Access Compliance Report

Public Rights-of-Way

Intersection ID: 3423	Main Street: OVERLOOK_MOUNTAIN_DR	Cross Street: SOLEMN_POINTE_LN	Location: NW
ADA ID: EA7705A40503	Ramp Type: Perp	Initial Pass/Fail: Fail	Overall Compliance: No
Severity Score: 8.75			
Codes/Mitigation Info/Possible Solution		Field Measurements/Component Compliance

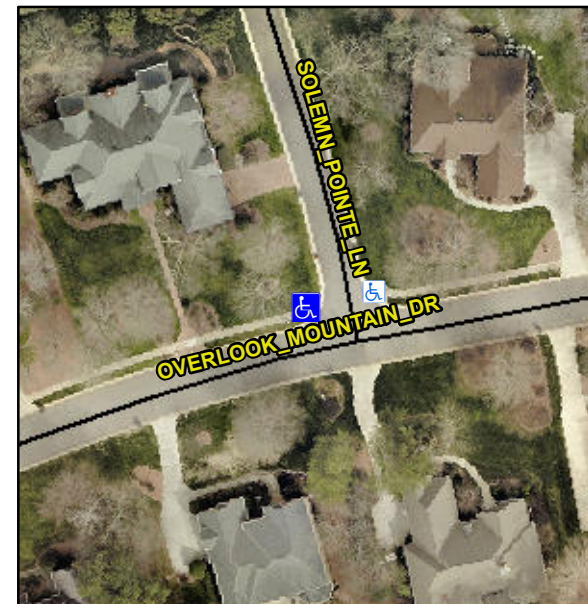
R304.5.1

Compliance	Description	Data	Compliance	Description	Data
N/A	Ramp Length (in)	95.0	Yes	Ramp Slope (%)	7.2
No	Ramp Width (in)	44.0	Yes	Ramp XSlope (%)	0.1
N/A	Flare Type LT	N/A	N/A	Flare Type RT	N/A
N/A	Flare Slope LT (%)	N/A	N/A	Flare Slope RT (%)	N/A
N/A	Flare Traversable LT?	N/A	N/A	Flare Traversable RT?	N/A
N/A	Landing Length (in)	N/A	N/A	DWS Provided?	N/A
N/A	Landing Width (in)	N/A	N/A	DWS Contrast?	N/A
N/A	Landing Slope (%)	N/A	N/A	DWS Length (in)	N/A
N/A	Landing X Slope (%)	N/A	N/A	DWS Full Width?	N/A
N/A	Landing Curb? (Y/N)	N/A	N/A	DWS Offset (in)	N/A
N/A	Shared Landing?	N/A			
N/A	Gutter Ponding?	N/A	N/A	Gutter Slope (%)	N/A
N/A	Gutter Lip Ht (in)	N/A	N/A	Gutter X Slope (%)	N/A
N/A	Painted X Walk1?	No	N/A	Painted X Walk2?	N/A
	X Walk 1 Direction	To E		X Walk 2 Direction	N/A
N/A	X Walk 1 Width (in)	N/A	N/A	X Walk 2 Width (in)	N/A
	X Walk 1 Slope (%)	0.2		X Walk 2 Slope (%)	N/A
	X Walk 1 X Slope (%)	2.4		X Walk 2 X Slope (%)	N/A

Remove & Replace Entire Ramp.
